METROPOLITAN GOVERNMENT OF NASHVILLE AND DAVIDSON COUNTY

STAFF RECOMMENDATION
1804 Lakehurst Drive
November 19, 2014

Application: New construction – outbuilding; Detached accessory dwelling unit
District: Lockeland Springs-East End Neighborhood Conservation Zoning Overlay
Council District: 06
Map and Parcel Number: 08310027700
Applicant: Craig Kennedy, Architect
Project Lead: Sean Alexander, sean.alexander@nashville.gov

<p>Description of Project: The applicant proposes to demolish a non-contributing outbuilding and construct a new two-story detached accessory dwelling unit behind the primary building.</p> <p>Recommendation Summary: Staff recommends approval of the proposed outbuilding, with a condition that the windows and doors are submitted for staff approval and that the restrictive covenant is filed prior to permitting. With those conditions met, Staff finds that the proposed outbuilding meets the applicable design guidelines and additional requirements.</p>	<p>Attachments A: Photographs B: Site Plan C: Elevations</p>
--	--

Existing Outbuilding, To Be Demolished.

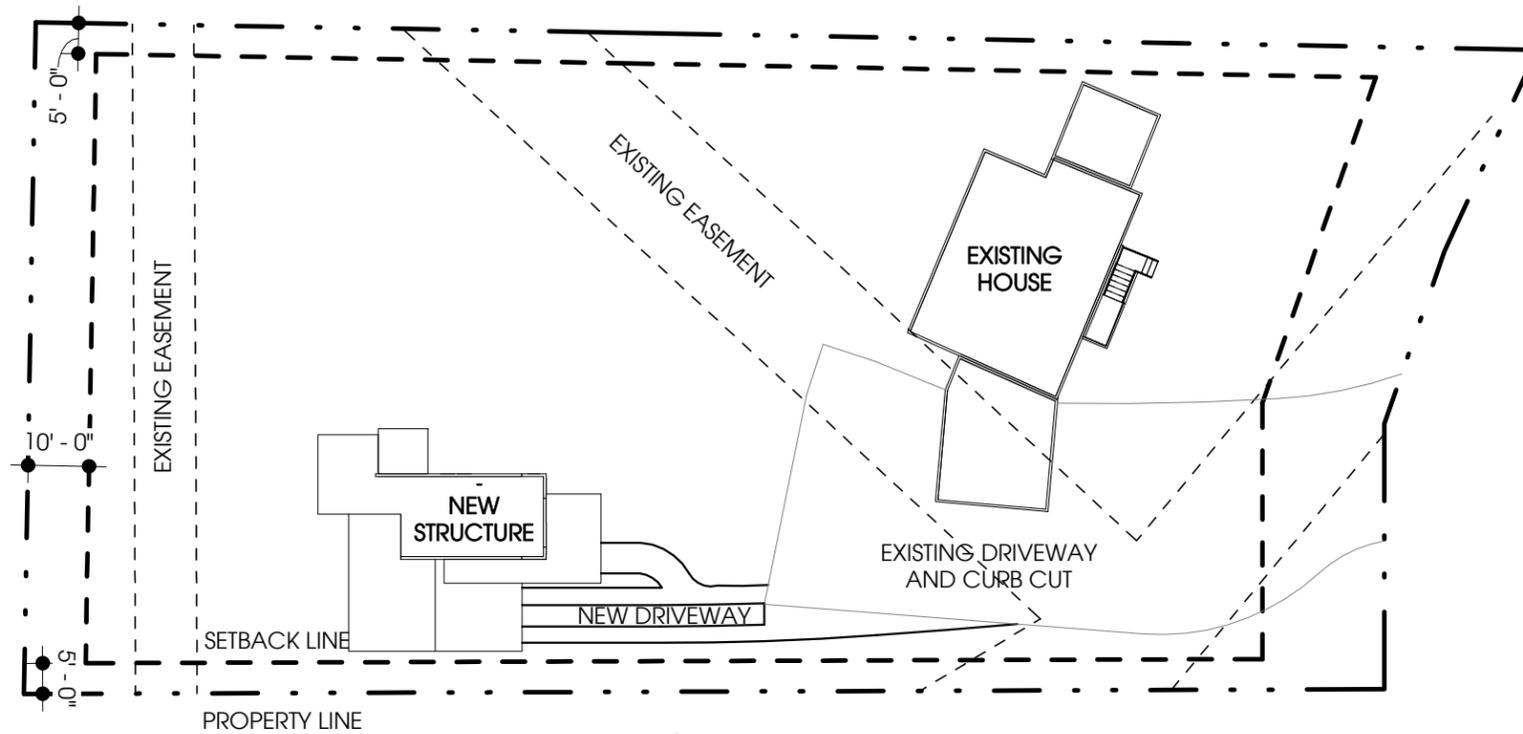
Demolition: The existing outbuilding is not historic, and does not contribute to the character of the district. Staff therefore finds that its demolition meets Section III.B.2 for appropriate demolition and does not meet section III.B.1 for inappropriate demolition.

ELEVATIONS

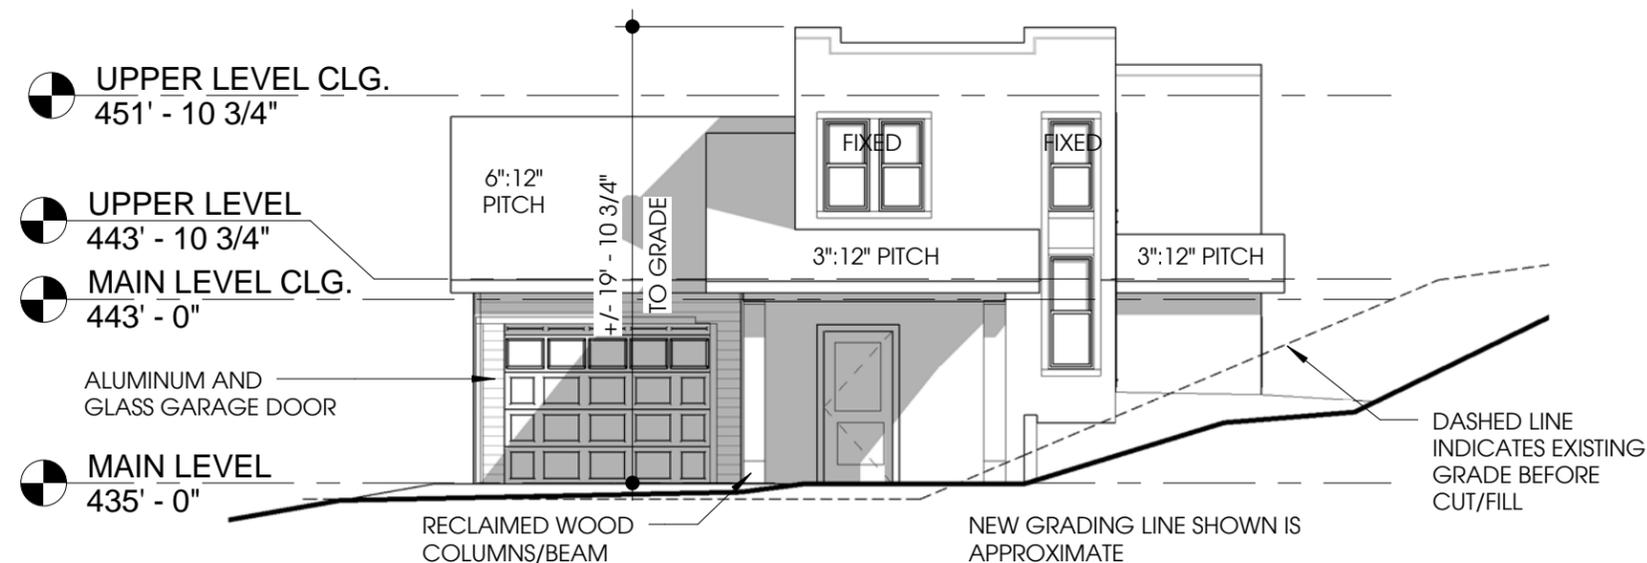
Character, Materials, and Details: The principal building is typical of the Spanish Eclectic style of architecture, with a flat roof behind a parapet and textured stucco walls. Other prominent features on the building include arches and buttresses. The proposed outbuilding would match the house in character, with similar roof form and detailing.

The primary exterior wall material of the outbuilding will be stucco, matching the texture of the walls of the principal building. Cement-fiber siding with a smooth finish and five inch (5") reveal will be used as secondary wall material. The exterior trim, including window casings and cornerboards will be cement-fiberboard. The flat roof portions will be white EPDM, and will be obscured behind the parapet walls. The pitched roofs will be fiberglass shingles in black, gray, or brown. The material of the windows and doors is not known at this time. With a condition that staff approves the specific window and door selections, Staff finds that the proposed building would meet guideline II.B.8.a.

Roof: The primary roof form of the proposed outbuilding will be a flat roof behind a parapet. This roof matches the form of the principal building, and other historic houses in the surrounding area. Staff finds that the proposal would meet guideline II.B.8.a.

Windows and Doors: The windows on the proposed outbuilding will be generally twice as tall as they will be wide, which is consistent with the proportions on windows on historic houses nearby. The front door of the building will be half-glass, and the garage door will have simple panels with square windows at the top. These doors are appropriate to the style of house, and meet guideline II.B.8.a.

Staff recommends approval of the proposed outbuilding, with a condition that the windows and doors are submitted for staff approval and that the restrictive covenant is filed prior to permitting. With those conditions met, Staff finds that the proposed outbuilding meets the applicable design guidelines and additional requirements.
